Form 3160-5 (June 2015)

## SUNDRY NOTICES AND REPORTS ON WELLS

Do not use this abandoned well	6. If Indian, Allottee of	r Tribe Name			
SUBMIT IN T	RIPLICATE - Other ins	tructions on page 2		7. If Unit or CA/Agree	ement, Name and/or No.
Type of Well	er			8. Well Name and No. TURNER B 32	
Name of Operator     LINN OPERATING, LLC	Contact: DEBI GORDON E-Mail: dgordon@linnenergy.com			9. API Well No. 30-015-05191	
3a. Address       3b. Phone No. (include area code)         600 TRAVIS ST. SUITE 1400       Ph: 281-840-4010         HOUSTON, TX 77002       Fx: 832-209-4340				10. Field and Pool or Exploratory Area GRAYBURG JACKSON;SR-Q-G-S

### PROPOSED PLUG AND ABANDONMENT PROCEDURE

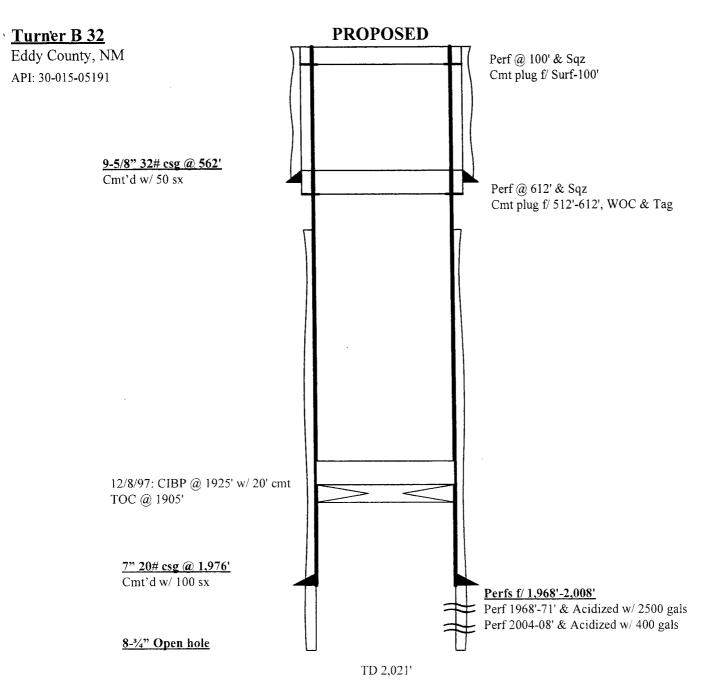
TOTAL TONS OF APPROVAL			
Below 91	round level dry hole .	nar	Ker required			
14. I hereby certify that the foregoing is true and correct.  Electronic Submission #393561 verified by the BLM Well Information System  For LINN OPERATING, LLC, sent to the Carlsbad						
Name (Printed/T	yped) DEBI GORDON	Title	REGULATORY MANAGER			
Signature	(Electronic Submission)	Date	10/31/2017			
	THIS SPACE FOR FEDERA	AL OR	STATE OFFICE USE			
	James a. Comes	Title	Super. AET Date	-6-17		
certify that the applica	al. if any, are attached. Approval of this notice does not warrant or ant holds legal or equitable title to those rights in the subject lease the applicant to conduct operations thereon.	Office	e CFO

1. RIH w/ tbg to PBTD @ 1905' Spot 25 5x ent. wec Tay
2. Circ well w/ MLF, POOH Part @ 1380, Saz ent to 1280. wec Tay
3. Perf @ 612' & Sqz, leave ent inside prod esg f/512-612', WOC & Tag 490. (Shee, T/satt)
4. Perf @ 100' & Sqz, leave ent inside prod esg f/ Surf-100'
5. Cut off wellhead, weld on below ground dry hale markets
